In the Planning and Environment Court

No 2916/24

NOTICE OF APPEAL

I, David Manteit of 82 Rowe Tce Darra 4076 appeals to the Planning and Environment Court at Brisbane against the decision made by Brisbane City Council on 25/9/24 of AOO6565555 and seeks the following orders set out on the following pages 3-21.

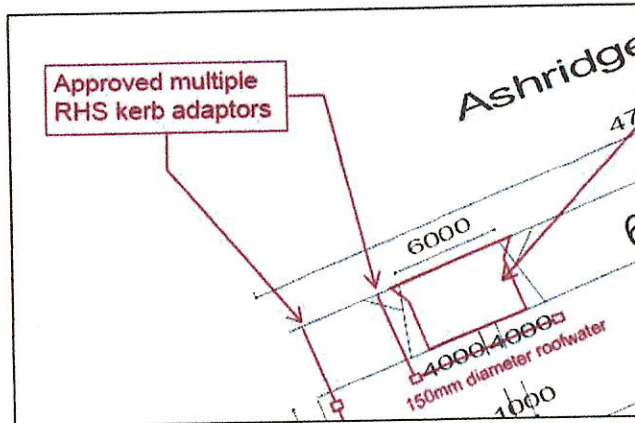
3. Re approved plan - "150mm diameter roofwater" red words and line to kerb to be deleted.

Red stamp and words "Approved multiple RHS kerb adaptors" Below to be removed.

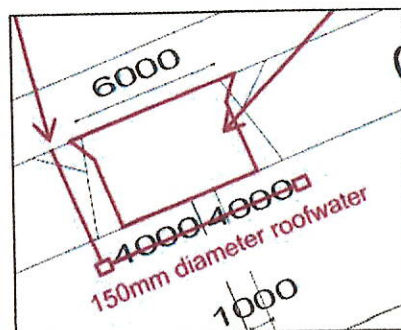
4. Re Approved Plan – Remove red stamp and words "Stormwater Markups are Indicative Only and subject to further detailed design." To be removed.

Remover red stamp "225mm diameter upslope connection pipe with .9m wide drainage easement."

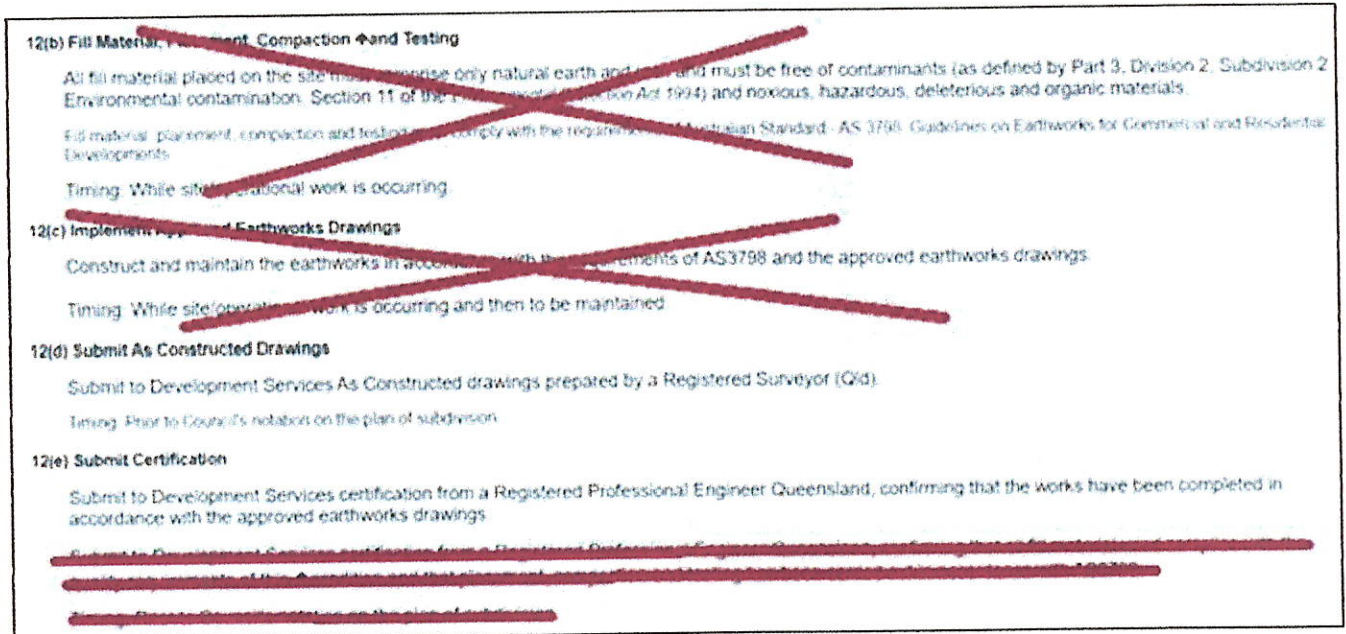
6. S 24

Red line/s amendment/s on plan below to be removed.

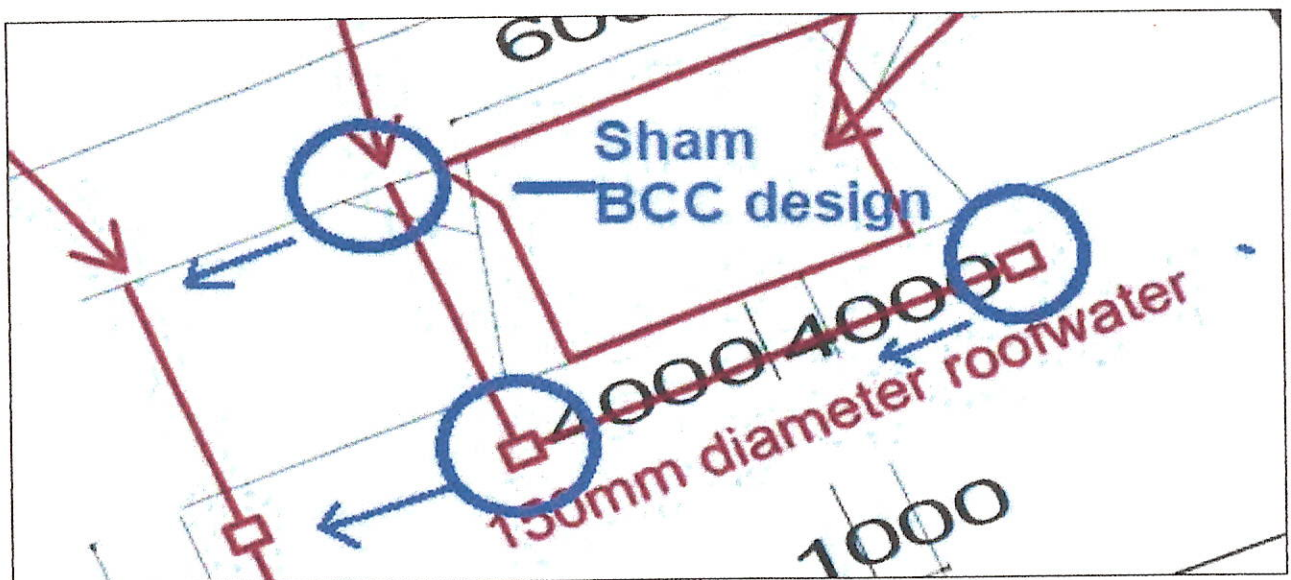
This Council prepared hydraulic plan "amended in red" is shown on the approved plan in the subject case.

This "amended in red" line and pits is evidence of poor design by Council in the above extract regarding internal roowater design.

The Council proposed location of internal pits some 4.9m and 4m from the right boundaries of the respective lots plus the location of the kerb crossing i4.9m from the right boundary indicate a lower than kindergarten ability to prepare hydraulic plans.

Identified -

No surface levels.

No invert levels.

Therefore no proof that the system works.

Above – approved plan of 134 Ashridge Rd Darra showing 150 pipe, 450 cover, 1:100 fall. Spot Marks to indicate evidence of AEP 1% compliance, , compliance with BSD 8111, 8BSD 8113 and BSD 8114.

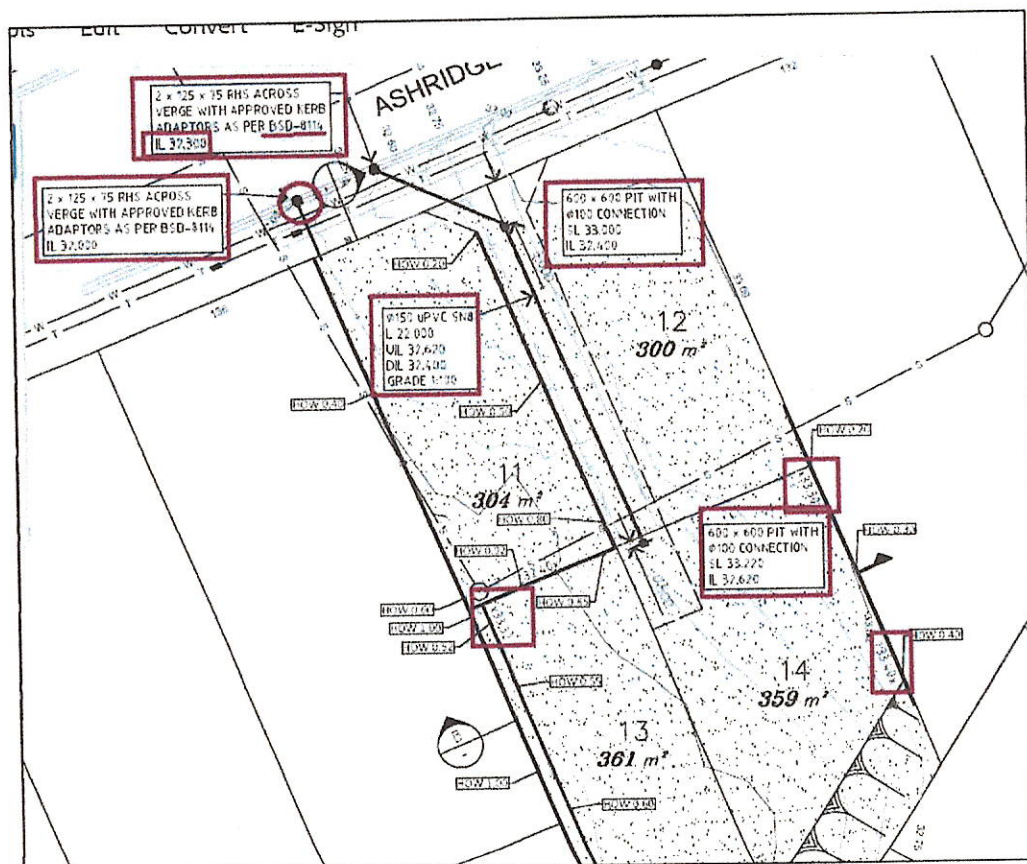
In order to prove my statement one only has to audit the internal hydraulica plan of 134 Ashridge Rd Darra for comparison. This was approved by Council in June 2024.

Identified - 150 pipe, 450 cover, 1:100 fall. Surface levels provided. Invert levels provided. AEP proper ground fall in addiiton to correct design. Spot levels to prove AEP. Design as per BSD 8111 exactly. Kerb crossing 500mm fromt right boundary as per BSD 8113. BSD 8114 kerb adaptors. An RPEQ designed the system.
